1114 E High Street
Special Exception for Build-To
and Transition Screening
Requirements

September 15th, 2025

Request and Staff Recommendation

A1

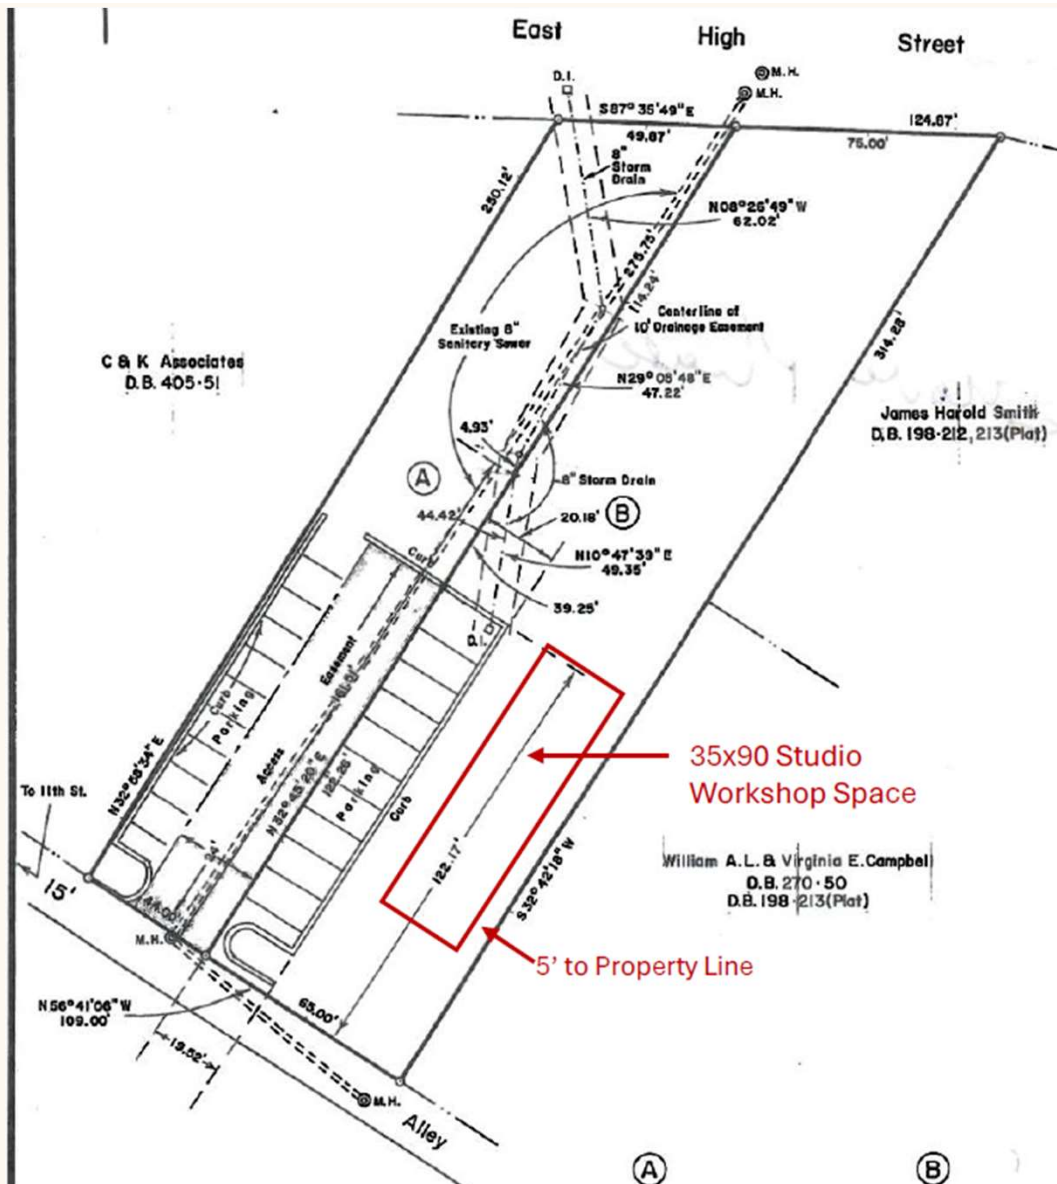
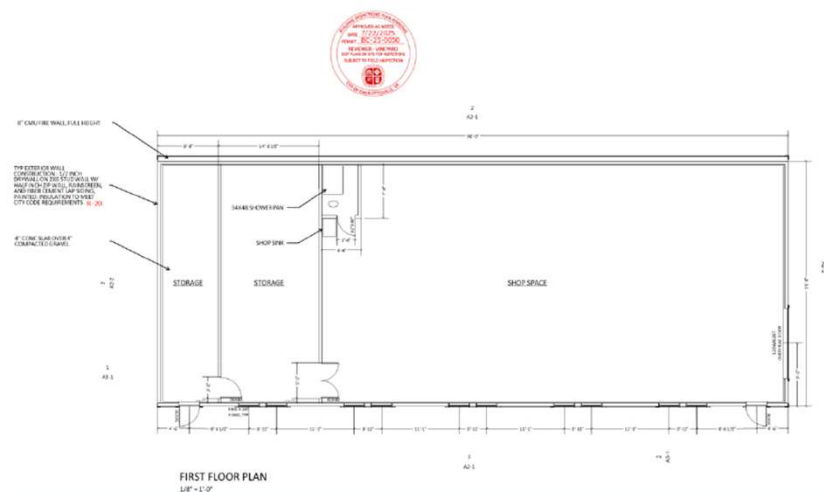
- Special Exception to allow building in the rear before build-to requirement is met; and special exception to modify Transition Screening requirements
 - Reduce the 20' building setback requirement to 5'
 - Reduce the Screening area depth from 8' to 5'
 - Reducing Large tree requirement from 2 to 0

- Special Exception to allow building in the rear before build-to requirement is met
- Special exception to modify Transition Screening requirements as follows:

- Reduce the 20' building setback requirement to 5'
 - Reduce the Screening area depth from 8' to 5'
 - Reducing Large tree requirement from 2 to 0
- Staff and Planning Commission recommends approval (7-0) of the SEP with the following conditions:

1. The size, location, and use will be consistent with the materials submitted in application PL-25-0038 and PL-25-0041 both dated August 12th 2025.
 2. Two large trees shall be provided on the subject property in accordance with Section 34-4.7 (Transition Screening). However, placement of these trees is not required between the studio workshop and the property line.

3. A minimum six (6) foot fence—existing or future—shall be provided between the studio workshop and the property line. The fence shall be maintained and kept in good repair.

4. The studio workshop shall not exceed one (1) story in height.
